# M5 Junction 10 Improvements Scheme

Statement of Common Ground  
Environment Agency  
TR010063 – APP 8.4

#### 8.3 Statement of Common Ground Environment Agency

<b>Version</b>	<b>Date</b>	<b>Status of Version</b>
Rev 0	October 2023	DCO Application
Rev 1	June 2024	Deadline 1
<a href="#">Rev 2</a>	<a href="#">September 2024</a>	<a href="#">Deadline 4</a>

Drawing Title: **FIGURE 1B FLOOD ZONE 3B SHOWING RELATIONSHIP TO THE SCHEME**

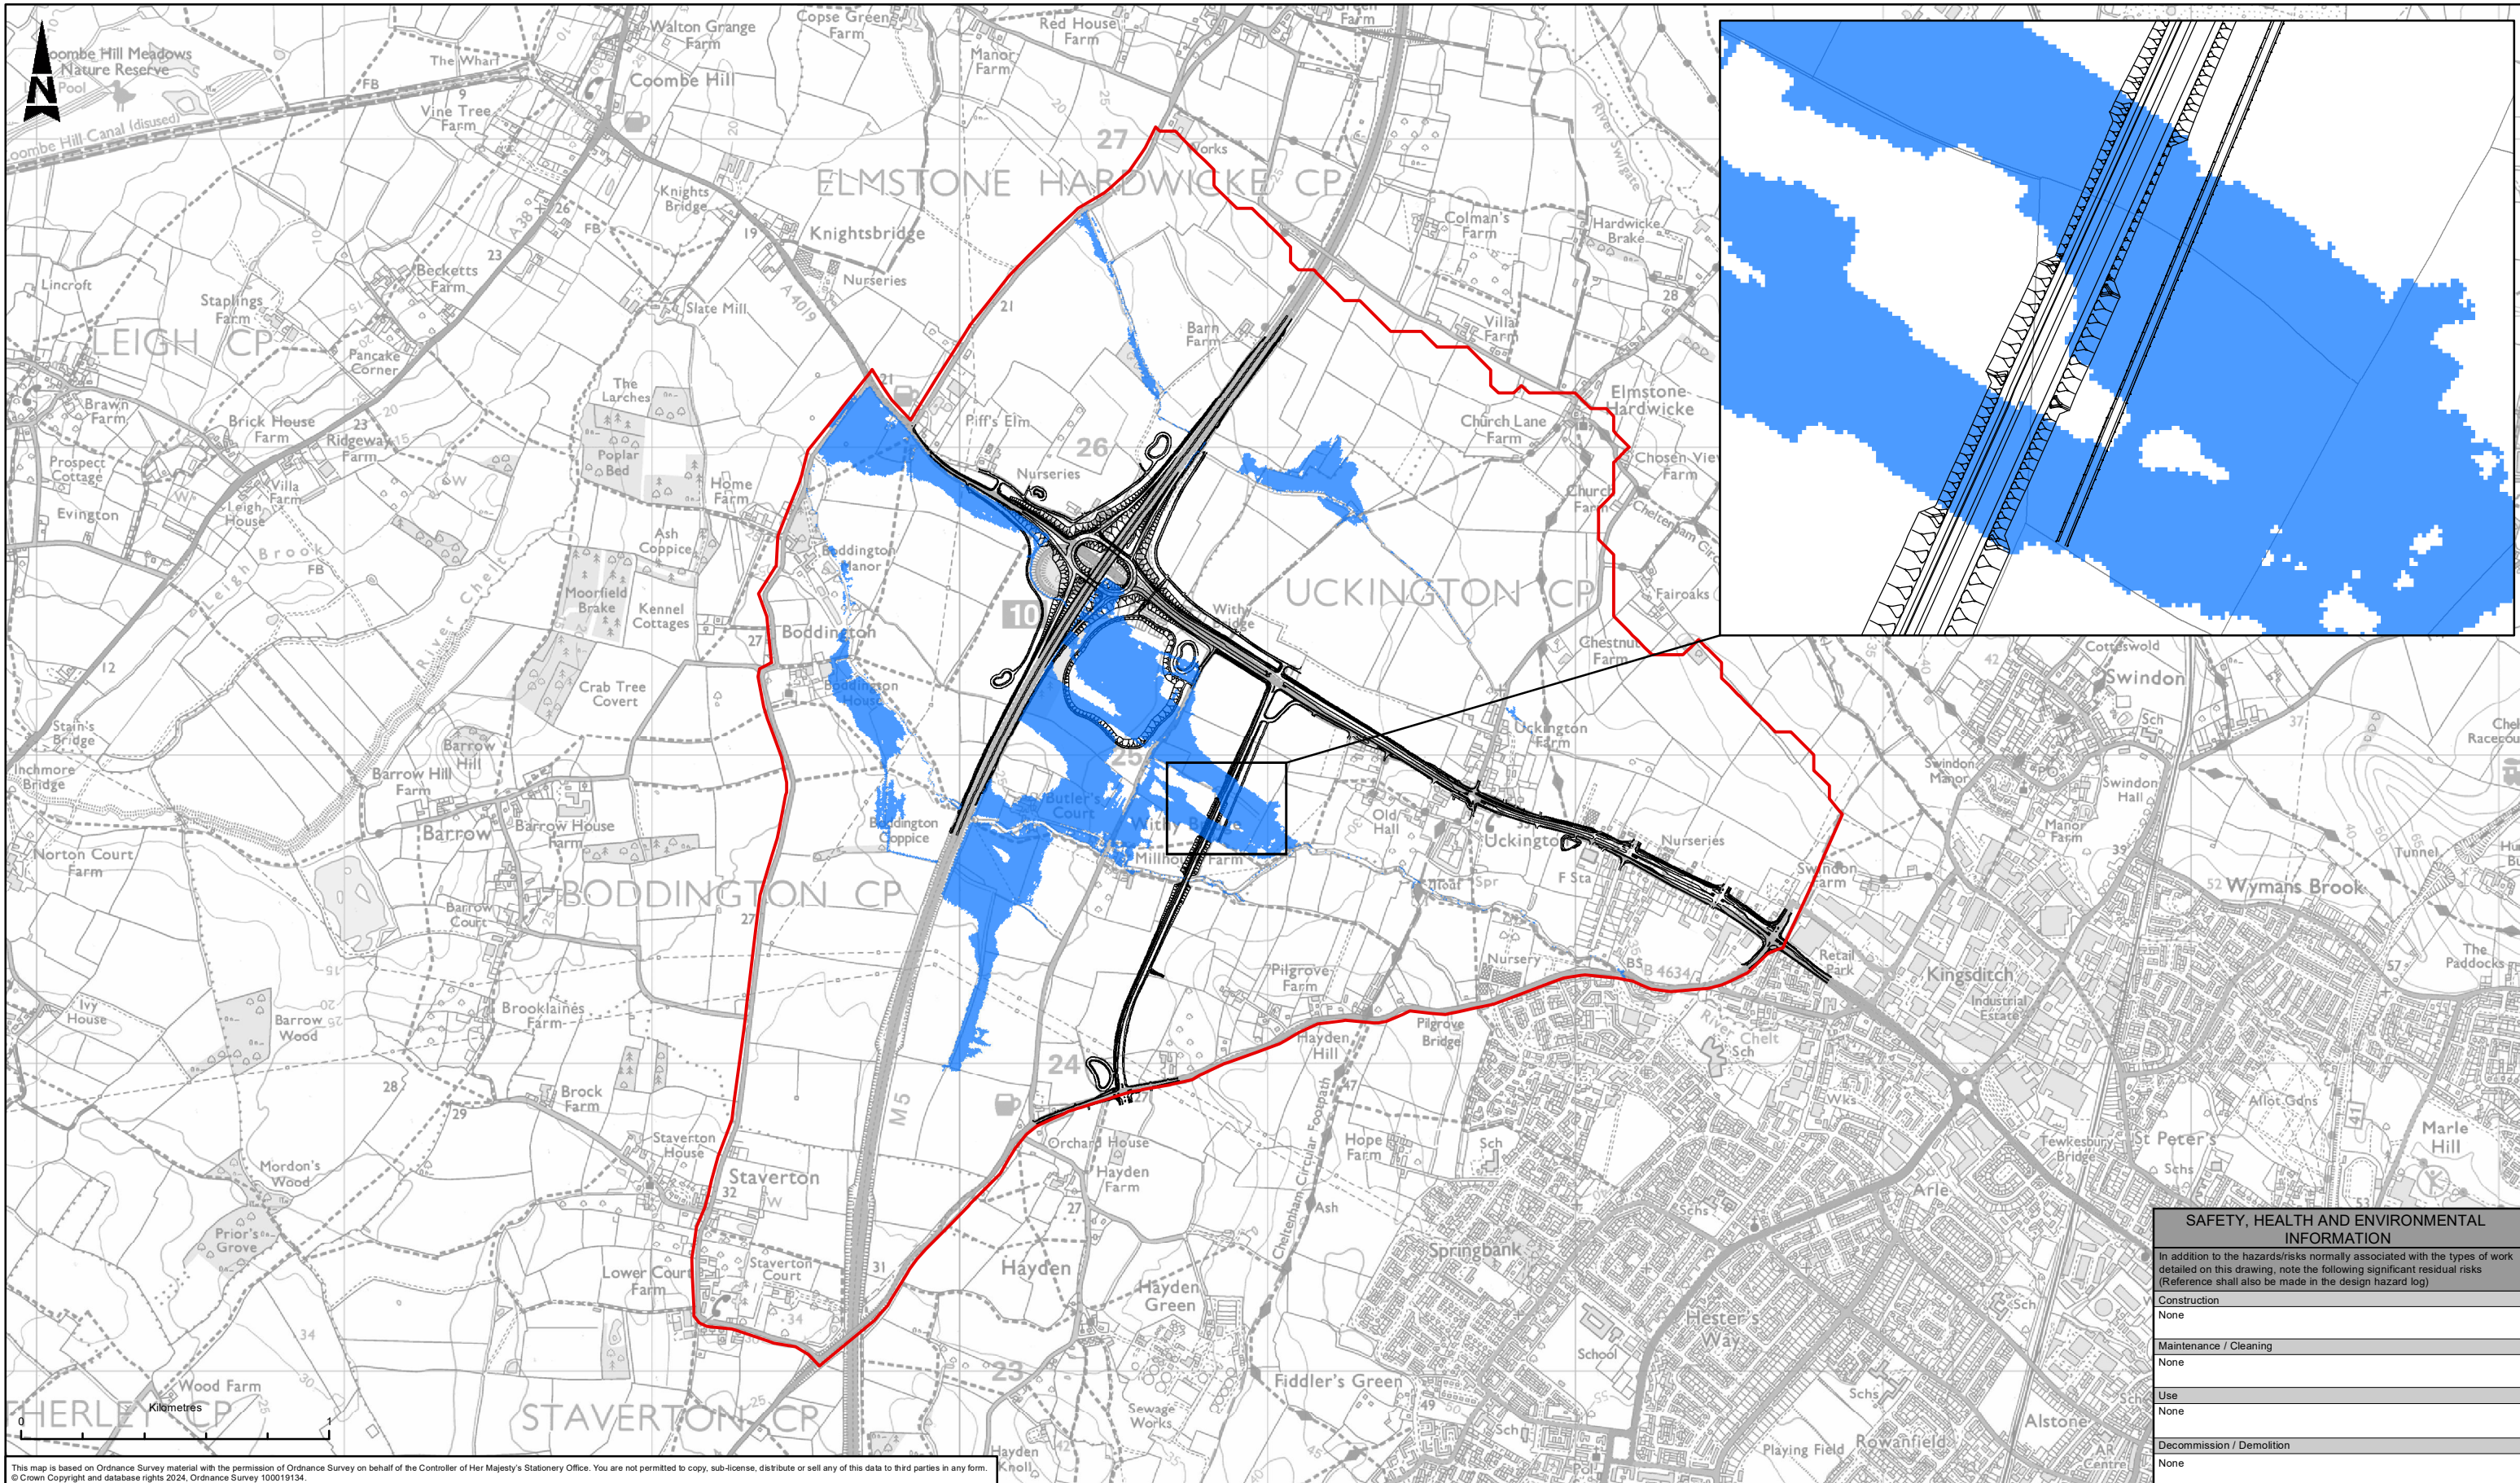
- A.1.4. We have now applied the 3.3% annual exceedance probability event (1 in 30-year return period) event to the model to specifically identify the floodplain equivalent to the updated FZ3b. This is indicated in the figure below – see Figure 1: Flood Zone 3b (3.3% annual exceedance probability event (1 in 30-year return period)).

Matters Reference Number	Position of Interested Party	Response	Date of the last position
		<p><u>As requested by the EA, the Applicant will add the FZ3b maps to the FRA report.</u></p> <p><u>At meeting held on 21.08.2024, it was agreed that the FZ3b maps will be added to the FRA and submitted to examination at Deadline 5. When this happens the matter can be agreed.</u></p>
